June 13, 2000

SUBJECT: Ogden Martin Systems of Lake, Inc.
DRAFT Initial Title V Air Operation Permit No. 0690046-001-AV
Written Comments on DRAFT Permit

**COMMENTS OF OGDEN MARTIN SYSTEMS OF LAKE, INC.
ON DRAFT TITLE V PERMIT NO. 0690046-001-AV**

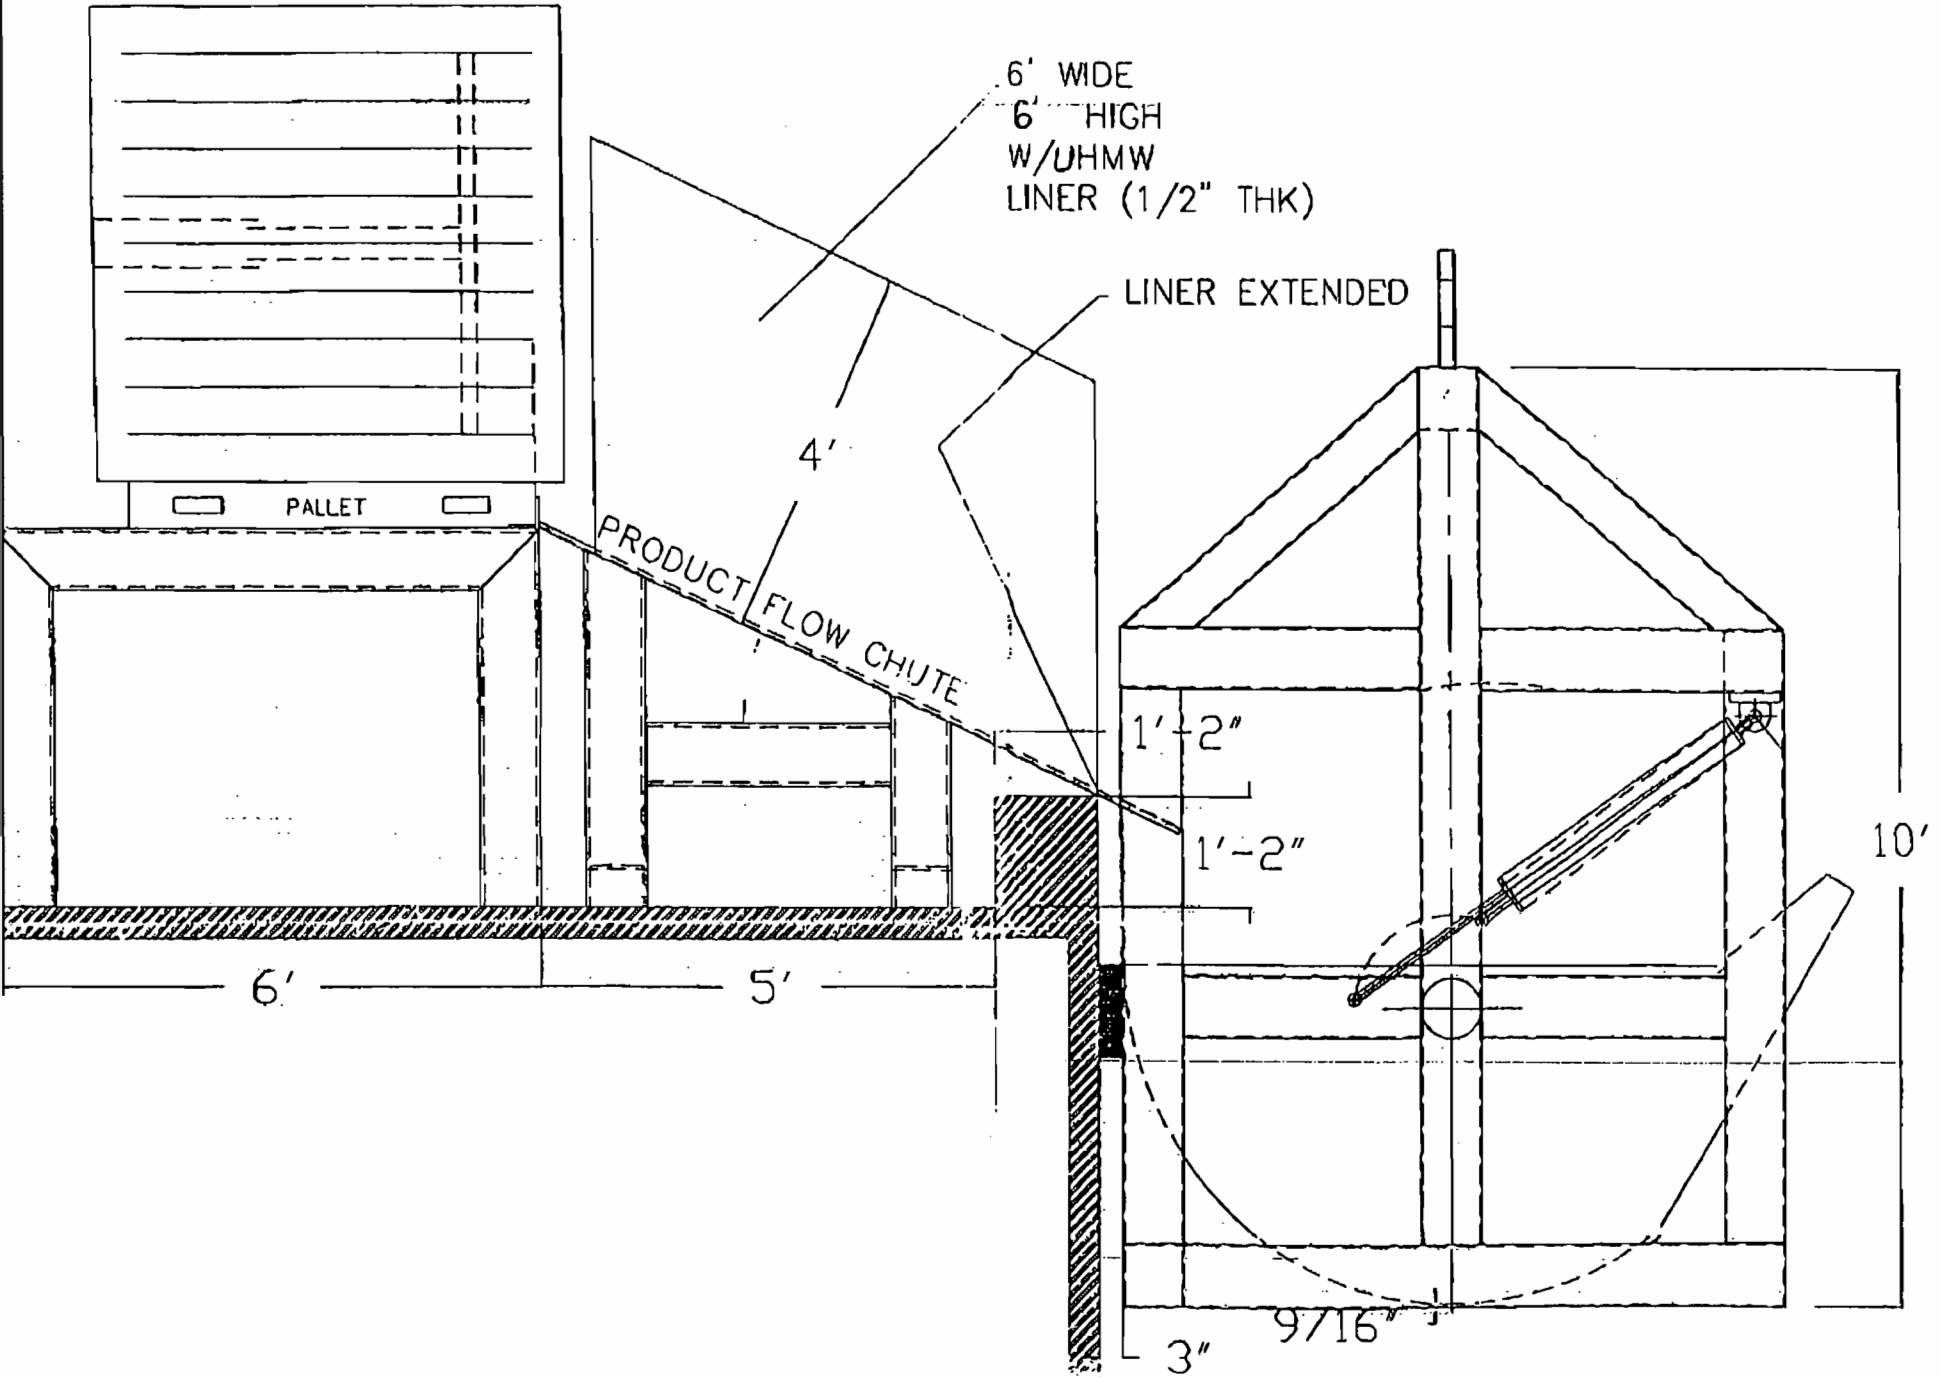
Attached, please find a preliminary drawing of the bucket. We believe that this system, used in conjunction with the existing conveyor, will enhance the facility's already excellent safety record. Thanking you in advance for your assistance in this matter, we look forward to your final guidance. If additional information is needed, please contact me at (352) 365-1611.

The information provided in your September 5 letter regarding the installation of a new more secure leak proof crane bucket at Unit #1 has been evaluated. The explanation of the proposed medical waste weighing system, weight recording order, and prevention of mixing medical waste with other municipal solid waste is acceptable.
